### *PPAP Package for:*

**Customer Name:** Newark Electronics  
**Customer Part Number:** 18J1397  
**(TE Connectivity Part Number):** 1-967626-4  
**May, 2020**

# Product Change Notification

Product Change Notification: E-19-016792

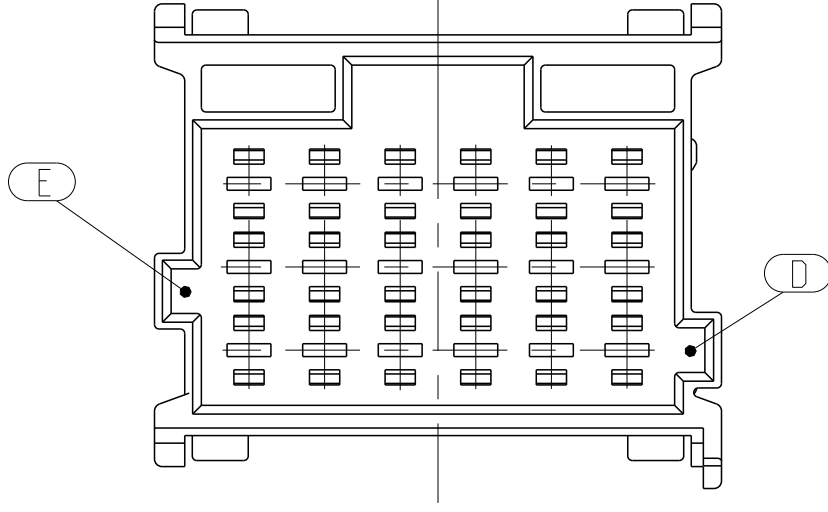
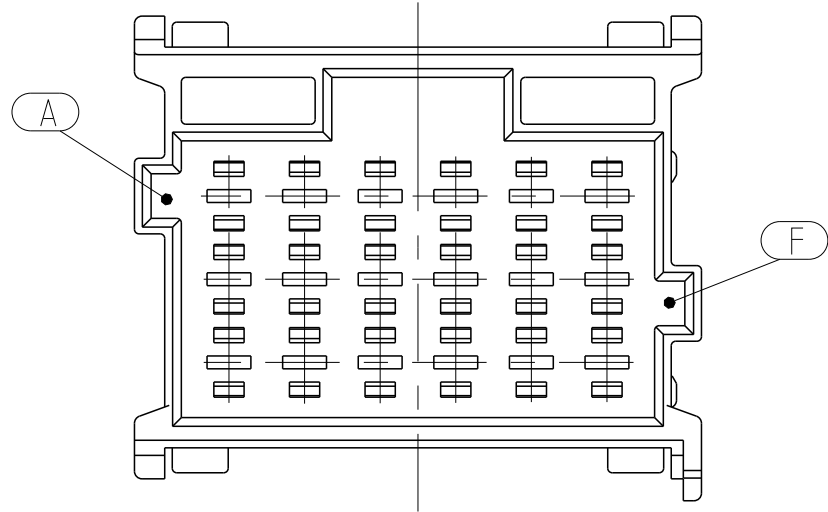
Change the raw material / resin from HS PBT-GF15 to PA66-GF13. Related TE production and customer drawings and all the 6-21 pos. AMP MCP 2,8 mm tab header part numbers' revisions will be updated.

CODING / Kodierung F				MECHANICAL CODING: mechanische Kodierung:	
RIBS / Nuten: A-F					
	6-967630-1	G	ORANGE / orange	21 POS. pol.	PA66-GF13 D E
	6-967629-1	G		18 POS. pol.	
				15 POS. pol.	
	6-967627-1	G		12 POS. pol.	
				9 POS. pol.	
	6-965641-1	G		6 POS. pol.	
CUSTOMER PART NUMBER Kunden-Einzel- teil-Nummer	TE ORDER-NO. TE Bestell-Nr.	REV.	DESCRIPTION Benennung Einzelteil		MATERIAL Stoff

CODING / Kodierung E				MECHANICAL CODING: mechanische Kodierung:	
RIBS / Nuten: E-D					
	5-967630-1	G	EMERALD GREEN / smaragdgruen	21 POS. pol.	PA66-GF13 <div>D</div> <div>E</div>
	5-967629-1	G		18 POS. pol.	
				15 POS. pol.	
	5-967627-1	G		12 POS. pol.	
				9 POS. pol.	
	5-965641-1	G		6 POS. pol.	
CUSTOMER PART NUMBER Kunden-Einzelteil-Nummer	TE ORDER-NO. TE Bestell-Nr.	REV.	DESCRIPTION Benennung Einzelteil		MATERIAL Stoff
